NOTICE OF VIOLATION
AND
PROPOSED IMPOSITION OF CIVIL PENALTIES

Illinois Power Company
Clinton Power Station

Docket No. 50-461
License No. NPF-62
EA 90-108

Report No.: 50-461/90005(DRS)

**FIGURE 2. Simplified SX Division 1 Schematic
(Major Heat Loads)**

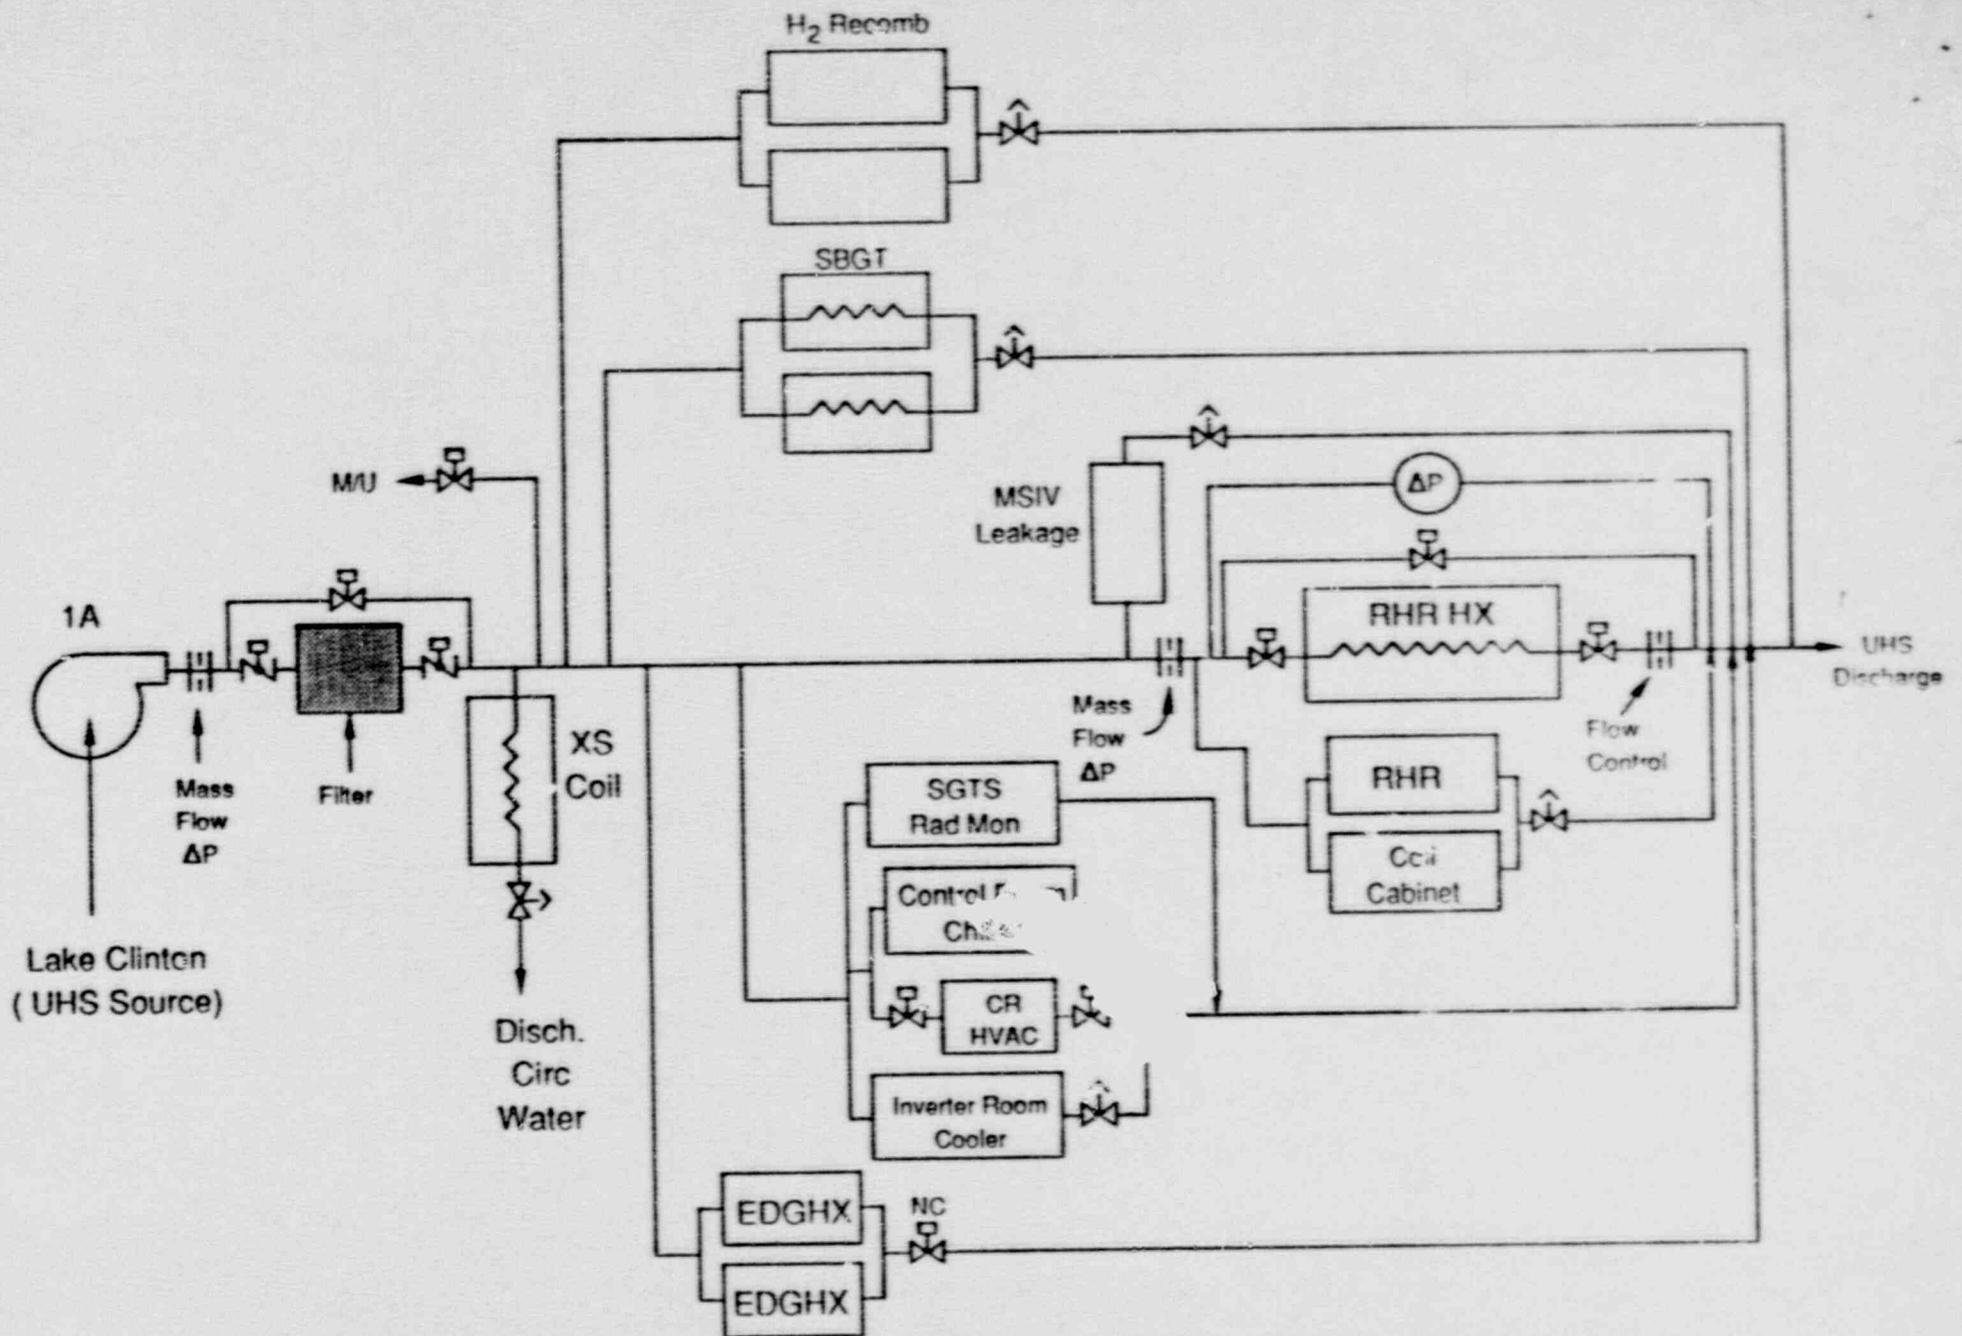
Suspecting that a global MIC condition could exist in the SX System, the licensee commenced an inspection of all Division I HXs (see Enclosure 3) to assess their physical condition. The remaining Division I HXs exhibited only minor tube wall pitting (maximum depth of 20% wall), along with moderate general corrosion and light siltation. The lack of evidence of widespread MIC attack supports the theory that the combination of thermal and stagnation conditions found in the EDG HXs promoted micro-organism growth and the resulting degradation of the copper-nickel tube wall.

FIGURE 4. Component Differential Pressure Drops

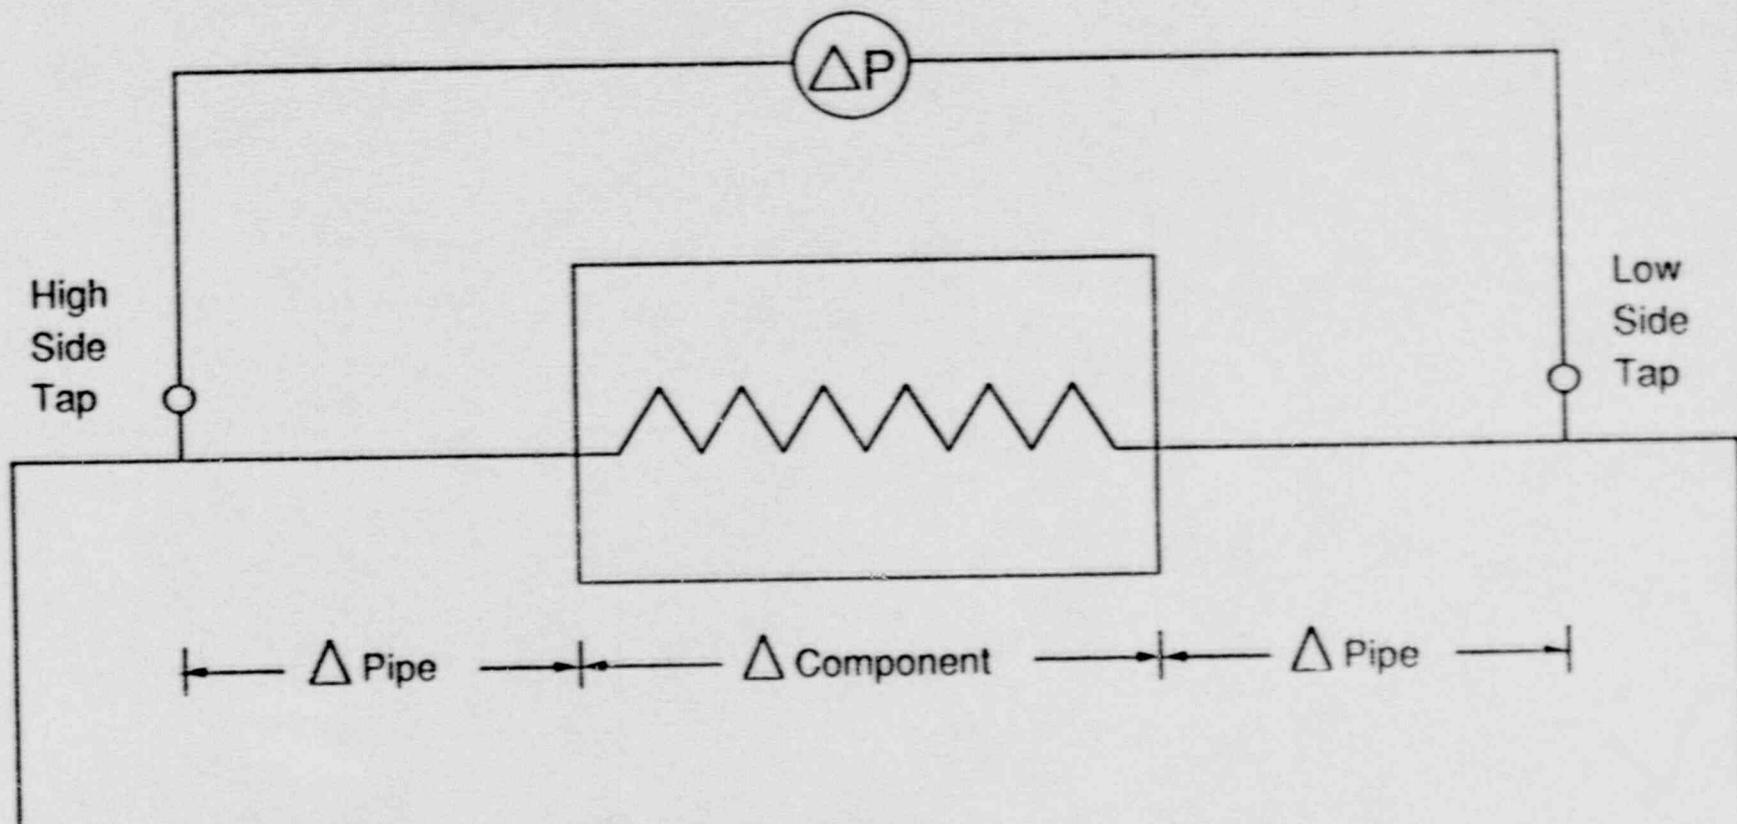
It was noted during the review that the acceptable flow rate values supplied by engineering made no additional allowances for any pressure drops between the taps for differential pressure measuring devices and the cooling coils. The vendor supplied pressure drop data was accountable only for the pressure drop across the coil. The actual locations of the instrumentation used during the preoperational tests could not be established, but assumptions were made of the possible pressure tap locations and additional line losses should have been accounted for. (Reference: Enclosure 4)
